### ADDENDUM #1

State Route 99 – Waterline Relocation Project  
Project Number 24-01  
Contract Number 2024-01

Prepared by  
City of Gridley, California

C-3A

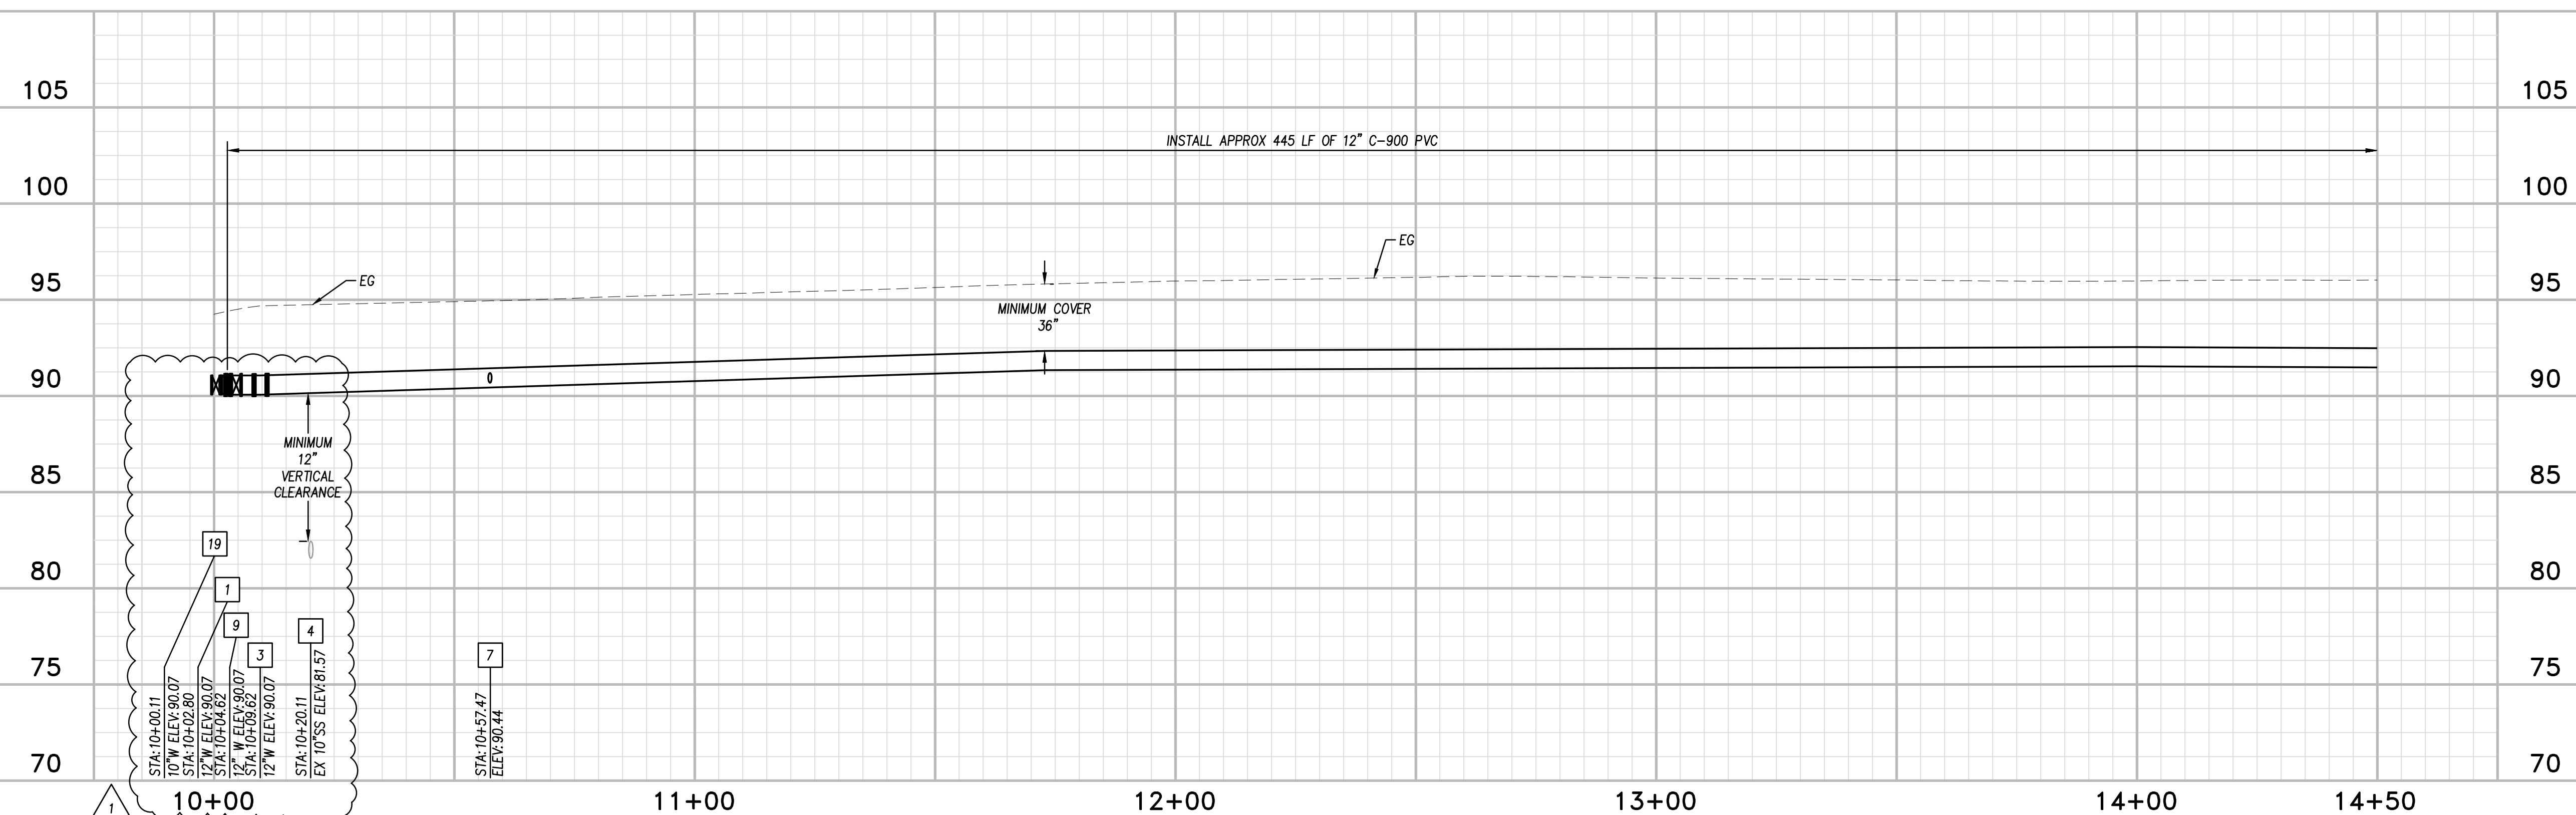
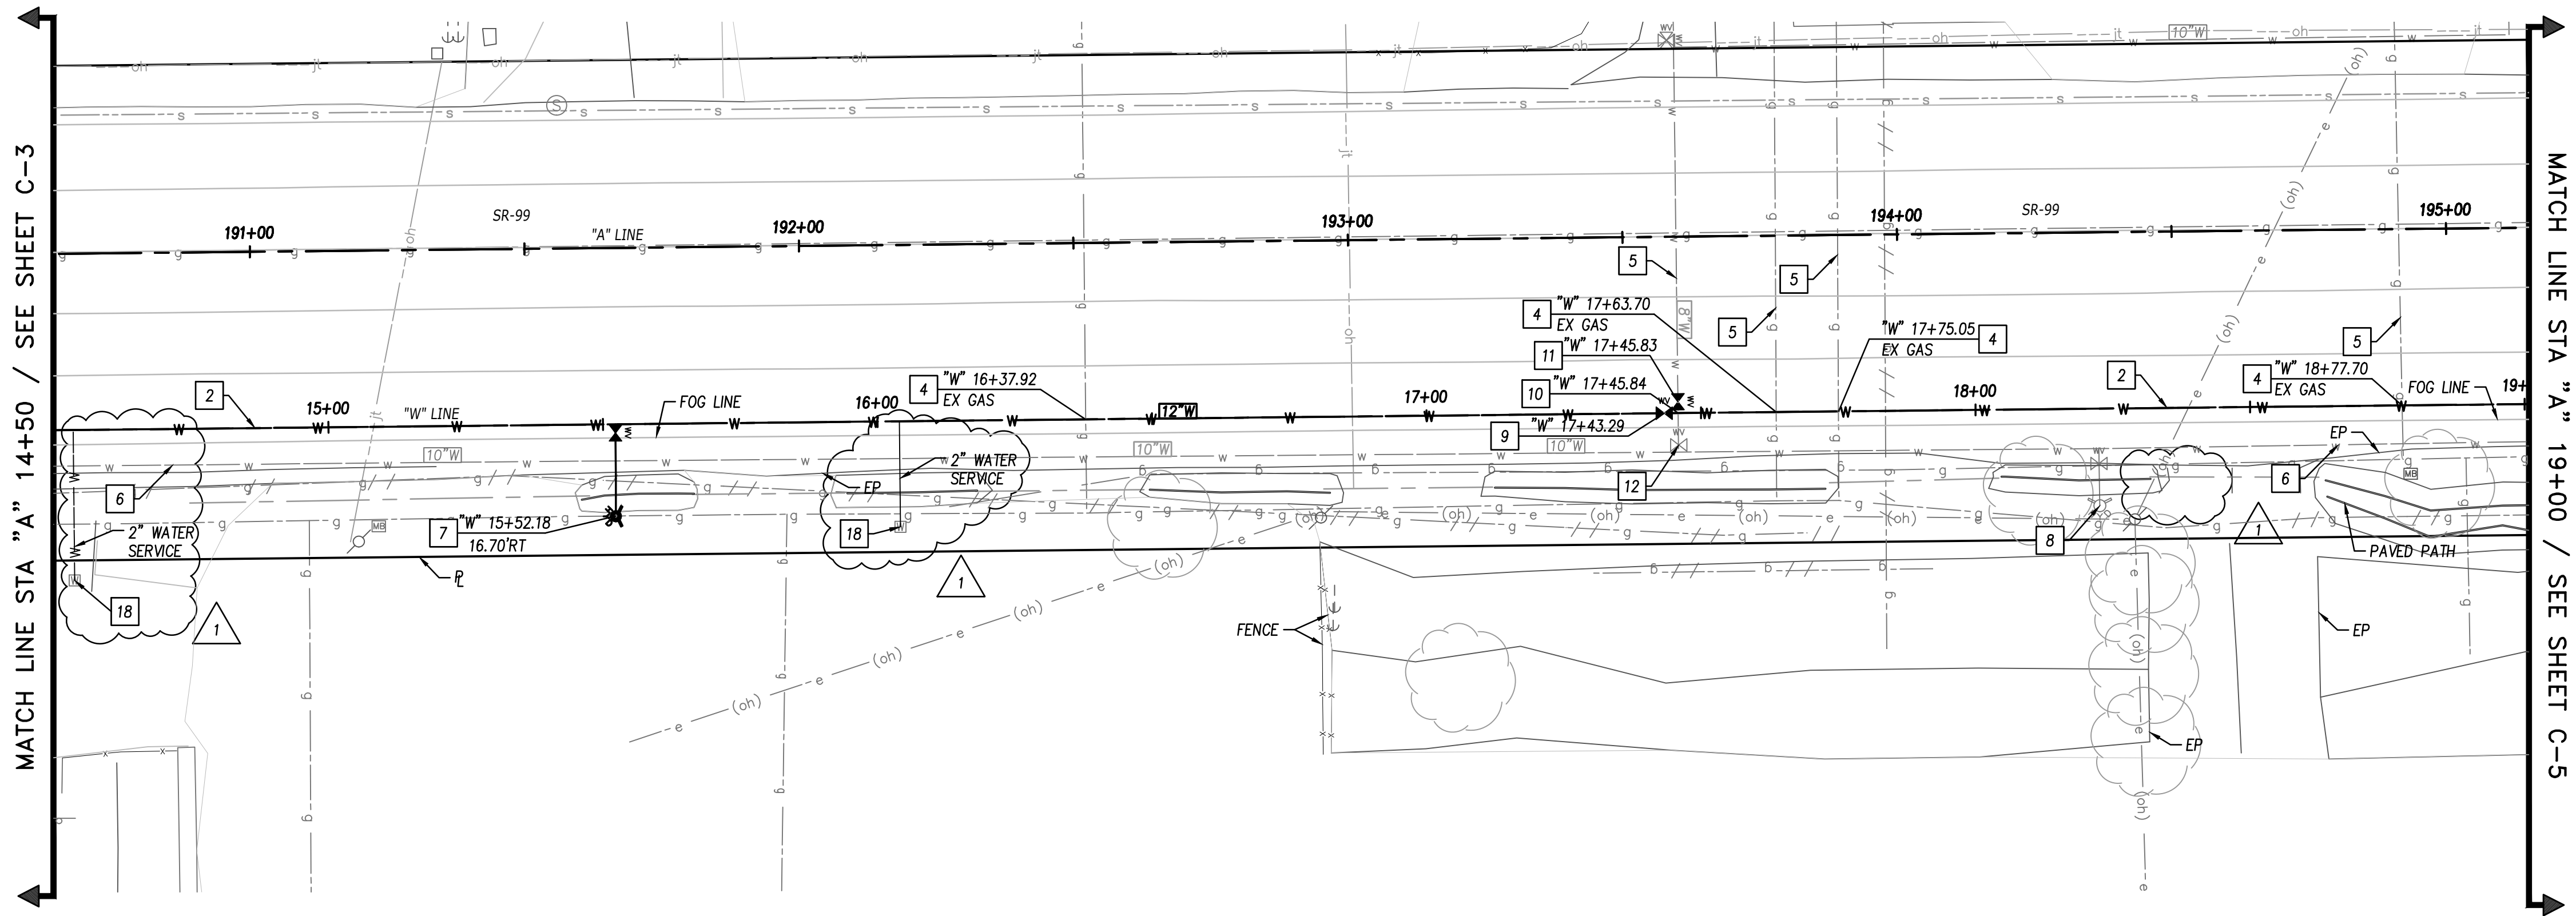
1. Sheet C-3, C-4, and C-5 to be replaced with revised sheets C-3A, C-4A, and C-5A.
  - a. Construction notes revised.
  - b. Proposed 10-inch and 12-inch gate valve labels have been corrected and added.
  - c. Service lateral reconnection locations added.
2. Detail 3 on sheet C-7 to be replaced with revised detail on sheet C-7A, see attached.
3. Detail 5 on sheet C-7 to be replaced with revised detail on sheet C-7A, see attached.
4. Details 1 and 2 on sheet C-6 have been moved to sheet C-7A and renumbered to details 6 and 7, see attached.
5. City details ST-32, ST-33, W-6, and W-16 have been added to sheet C-6A with revision notes, see attached.
6. City detail W-11 has been added to sheet C-7A.

## STANDARD DETAILS

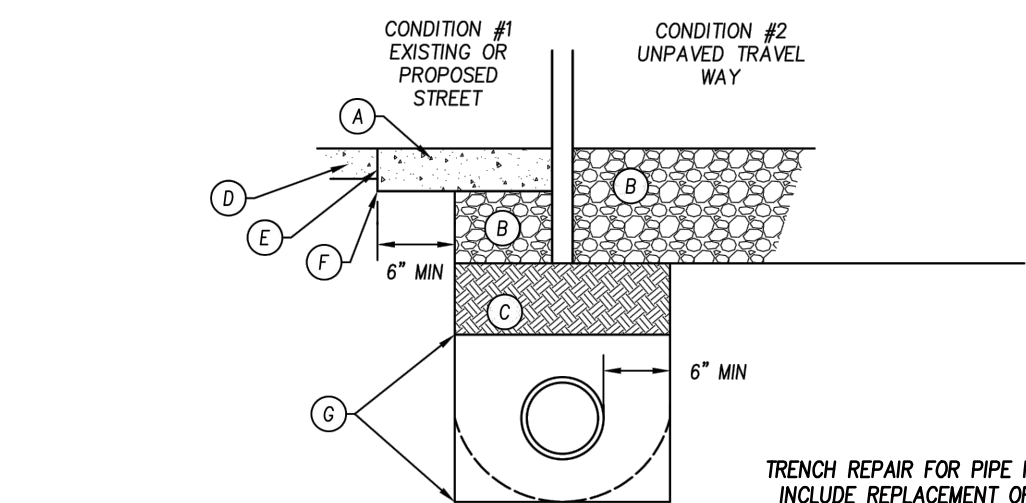
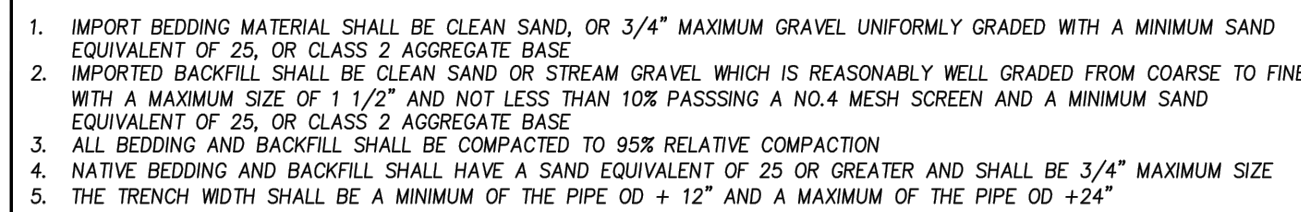
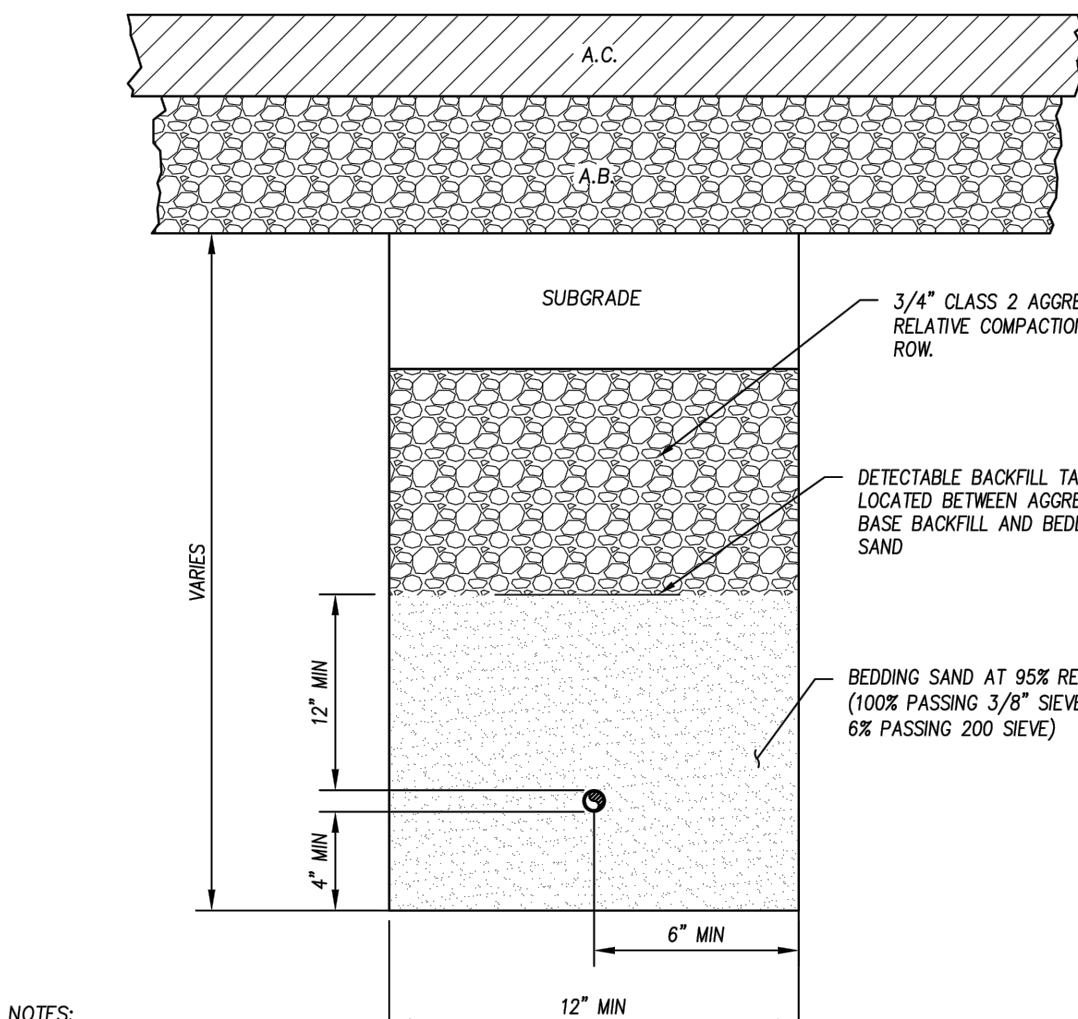
A: The cost of paving is to be included in the unit price for pipe installation or removal. Only a “T-section” trench patch is required. See attached C-6A for additions to the City's trench details that include the Caltrans structural sections requirements (0.85' HMA over 1.55' AB) or equivalent slurry cement backfill per State Standards and approved by Caltrans.

A: Per Caltrans depiction of existing conditions, it should be anticipated that there is 0.7 feet cement treated base under the asphalt. Trench excavation, which includes excavation of cement treated base is included in the bid price for water line installation or removal. A trench repair

section has been provided on Sheet C-6A, attached, to provide an equivalent structural section to meet Caltrans requirements. Also see answers for Q#2 and Q#3.

A: Bid Item #12 quantities have been revised. All existing service laterals are to be replaced from the new main to the service meter by contractor during construction. The locations of known service laterals are depicted by water meters shown on the plans, See revised plans with the this addendum. A service connection detail has been added to Sheet C-6A.
